ADA Curb Ramp New Construction Inspection Form (Perpendicular)

Nw 287

24952.54

Nw may

PERPENDICULAR RAMP (PR)

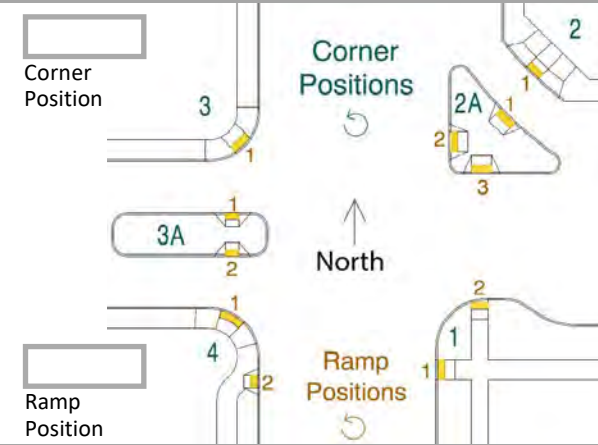
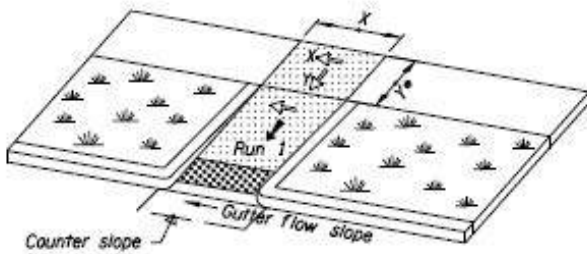
IITD RR1 fail
